Objection To :- The Uniting Kingscliff Redevelopment (SSD47105958)

I live at 37 Drift Court Kingscliff and am a direct neighbour to the proposed Uniting Kingscliff Redevelopment (SSD47105958). I object to the development in its current form based the items listed below.

Figure 1 Planting along and over Boundary Causing over shadow and View loss

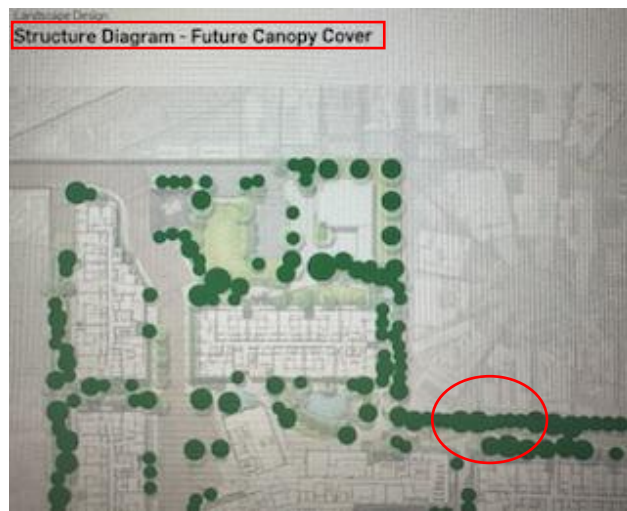
- The landscape design intent presented by the developer, (Appendix AA) shows planting along my boundary and future canopy diagrams appear to have been drawn OVER my boundary.

Figure 4 To scale silhouette of 37 Drift Court facing to west as indicated by the architects. Approx 100 large glazing panels overlooking our house.

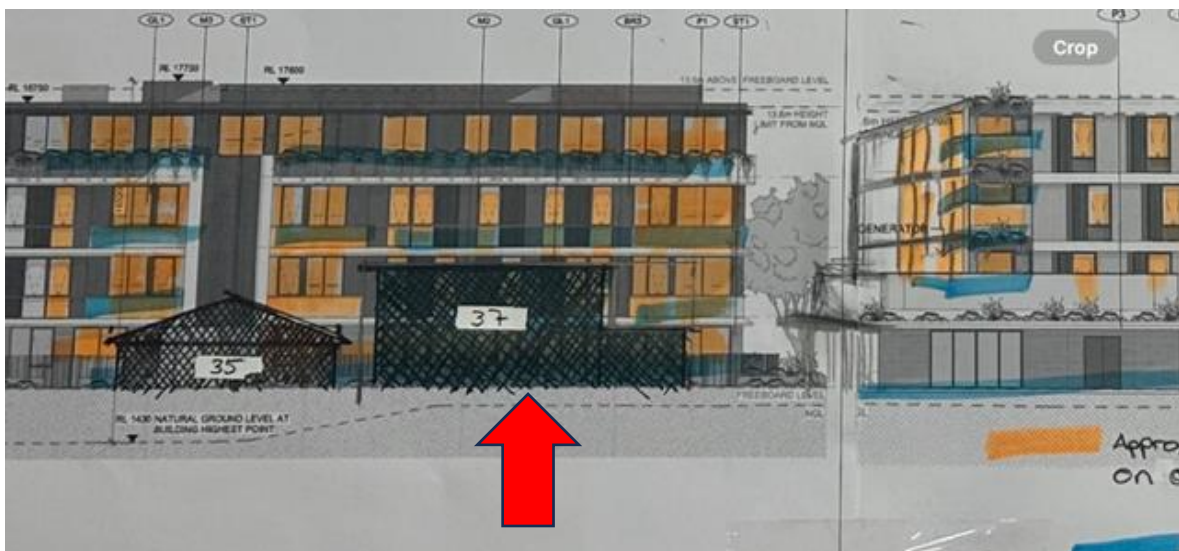
- Full length Windows , verandahs with glass balustrades look directly into our property with limited to no attempt to protect our privacy.

Figure 21 Coverage calculated across my boundary

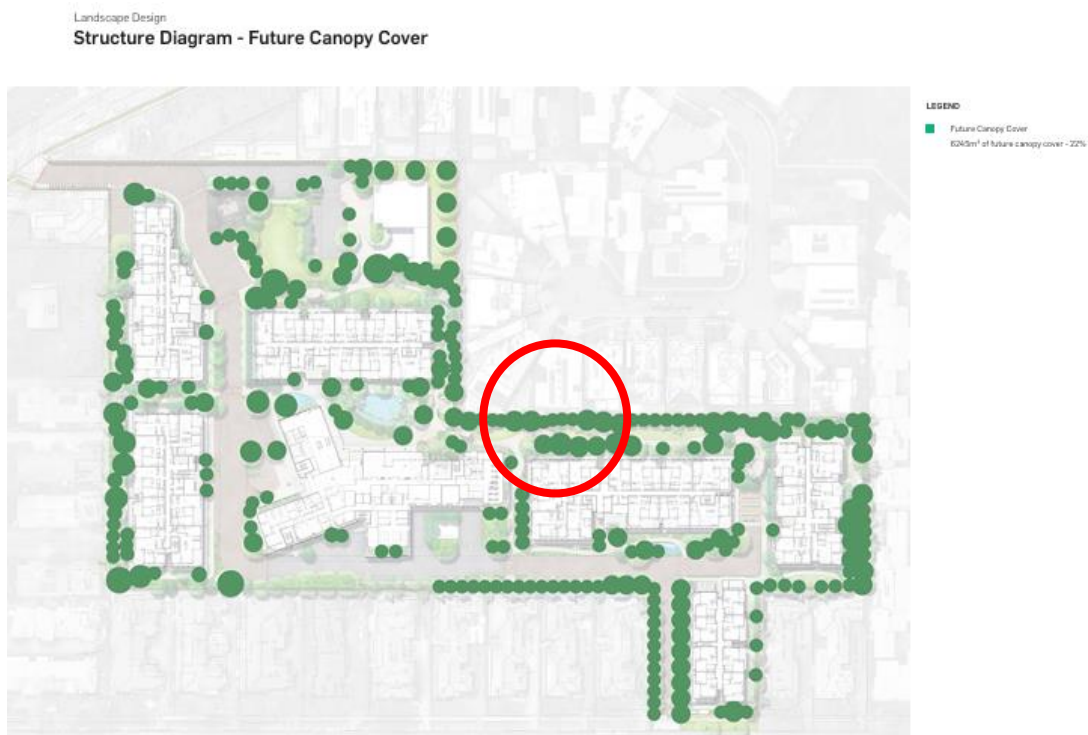
- **Intent to use trees** on our boundary to soften our outlook
- **Trees need to go in deep soil zones** that due to the basement **only exist on our boundary**
- The trees will **block any outlook** we may have and shade our open space and pool making our house **damp and cold** when our house is of passive design designed to absorb warmth in colder months and cool in hotter months.
- Tree coverage has been densified and calculated as tree coverage across my boundary.

Figure 23

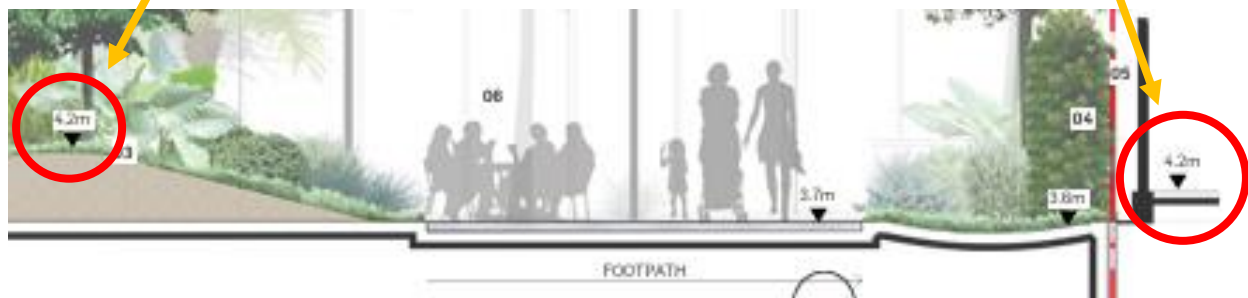
Heights Nominated on plans incorrect. Ground level above my floor level.

Figure 30 Area showing how Drift Court will be affected by flood water backup and run off when The approved Gales development site above the proposed Uniting site are filled to equal and above Drift Court

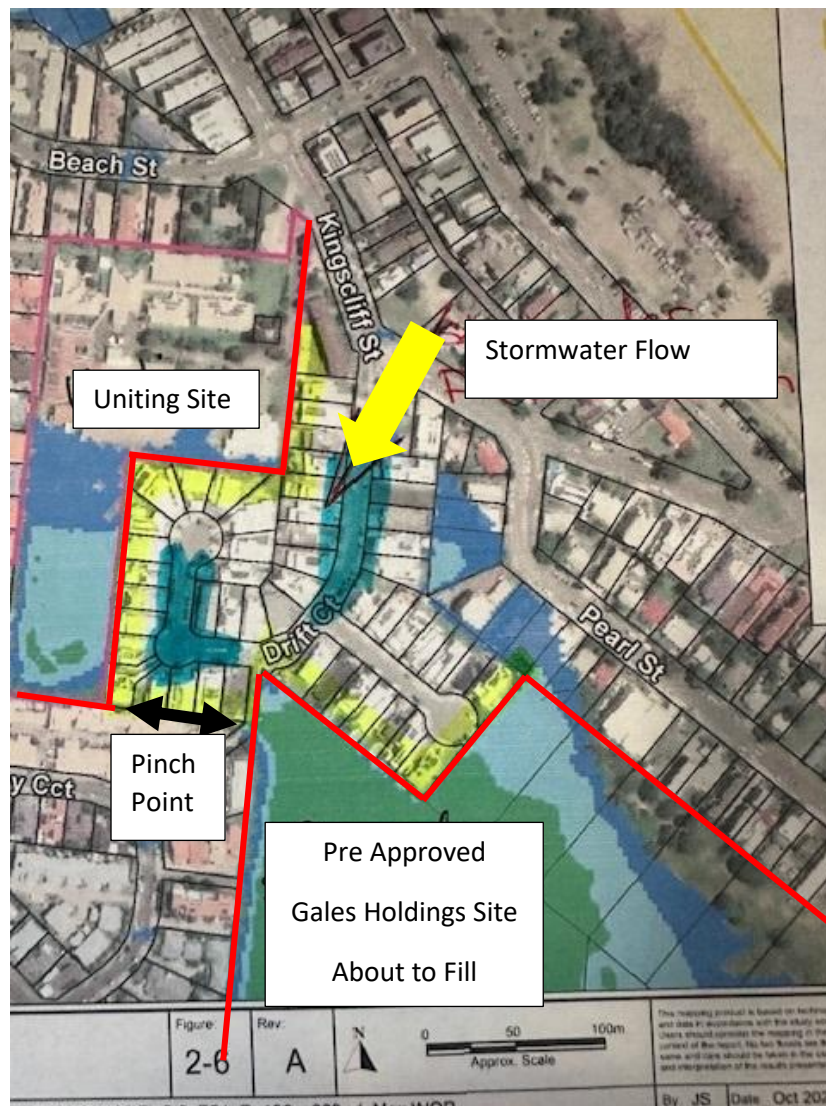
The Community is extremely concerned that another serious rain event that flooded and threatened to flood many properties to the west, east north and south of the proposed site will be further disadvantaged due to increased ground height on the Uniting site. This is likely to impede the natural dispersion of water and the damming effect worsening, due to the over development. We also see pinch points that will cause further buildup of water and probable flooding of houses in the future.

Figure 34 Orange line depicts Natural Ground Level. Local Environment Plan States No development over 13.6 from Existing Ground Level. This sits approximately in this section 1.3-2.0 m above the allowable height and by following the LEP drop off one Level

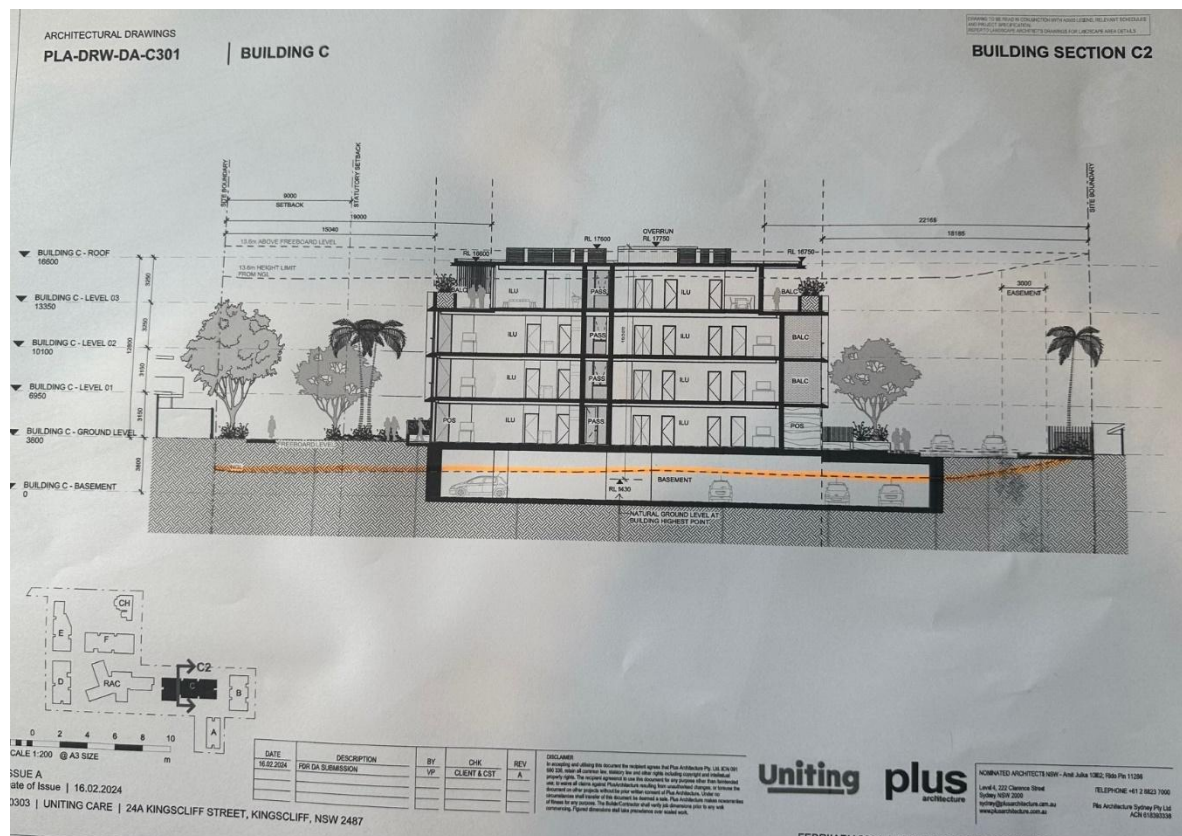
How can an uplift in height over the LEP be justified, at some places more than 3m above the maximum height above natural ground? To get the uplift that has been stated, words have stated that the top level will be stepped back – but this is NOT shown in the diagrams and is non-existent (refer to Figures 36 and 37)
